SUNDRY NOTICES AND REPORTS ON WELLS
Do not use this form for proposals to drill or to re-enter an abandoned well. Use form 3160-3 (APD) for such proposals.

8. Well Name and No.
CALM BREEZE 2 FED COM 704H

EOG Resources requests an amendment to our approved APD for this well to reflect the addition of a DV tool to the intermediate casing at approximately 5000 ft.

Lea County, New Mexico
Proposed Wellbore
Revised 7/18/17
API: 30-025-43649

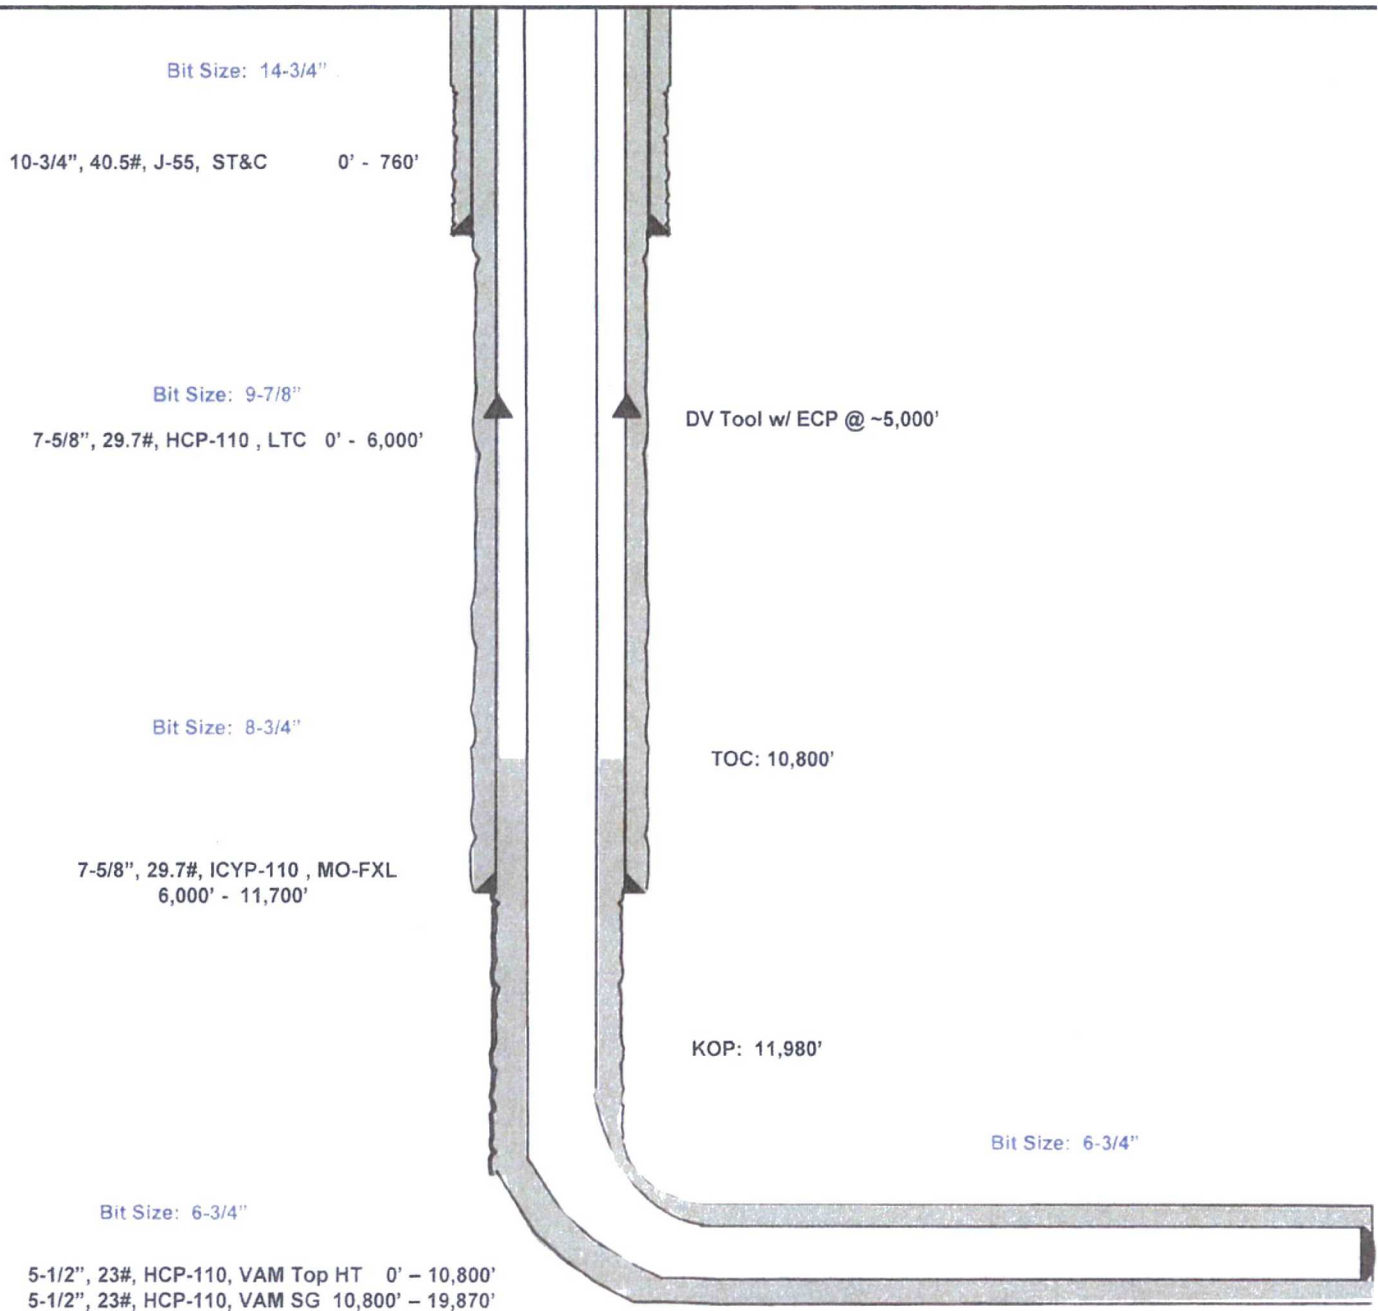
Cement details attached.

1. The minimum required fill of cement behind the 7 5/8 inch intermediate is:

Operator has proposed DV tool at depth of 5000', but will adjust cement proportionately if moved. DV tool shall be set a minimum of 50' below previous shoe and a minimum of 200' above current shoe. Operator shall submit sundry if DV tool depth cannot be set in this range. If an ECP is used, it is to be set a minimum of 50' below the shoe to provide cement across the shoe. If it cannot be set below the shoe, a CBL shall be run to verify cement coverage.
